## United States Department of the Interior

BUREAU OF LAND MANAGEMENT

Re: Fish Creek and the Resource Recovery and Protection Plan (R2P2), Co-Op Mining Company, Bear Canyon Mine, C/015/025

Overburden Section, Tank Seam

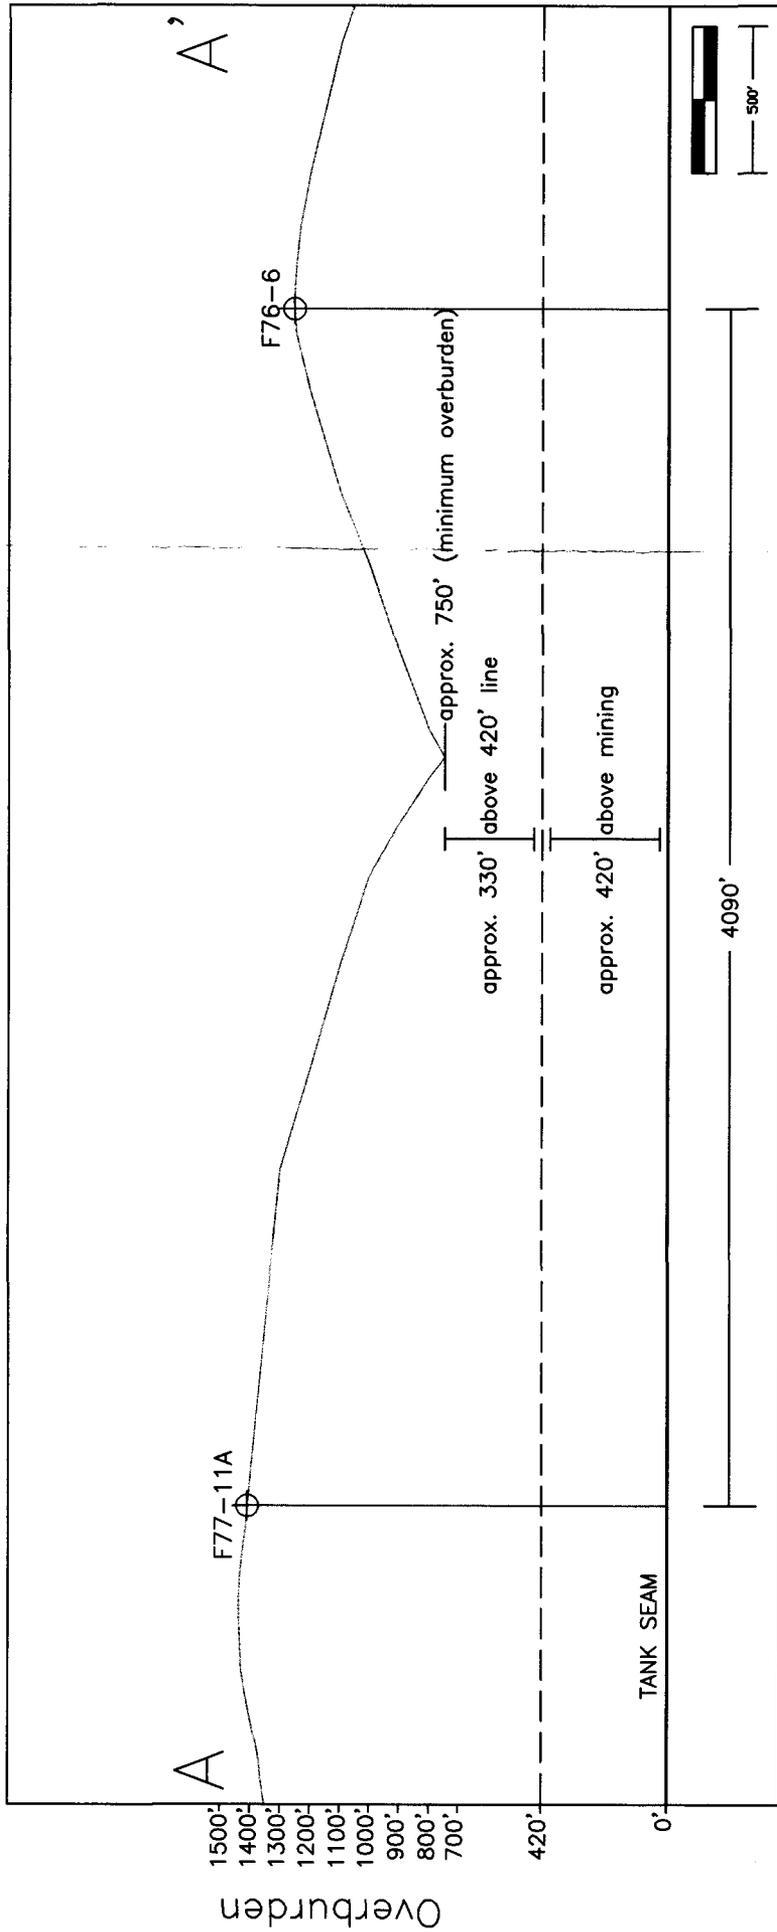
In reviewing the overburden map provided by Norwest Corporation ("International Energy, Mining, and Environmental Consultants") and maps showing the approximate location of the possible perennial sections of Fish Creek closest to the planned full extraction areas, BLM has found the minimum overburden to be some 750 feet (cross section attached). Because the coal thickness (and mining height) in the area is projected to be 7 feet, the minimum overburden, based on past precedence and work experience, is 420 feet. In this case, the overburden is approximately 330 feet more than the minimum.

Based on the above evaluation, the mine plan approved for submittal to the Assistant Secretary will continue in effect pending future mine plan modifications as warranted.
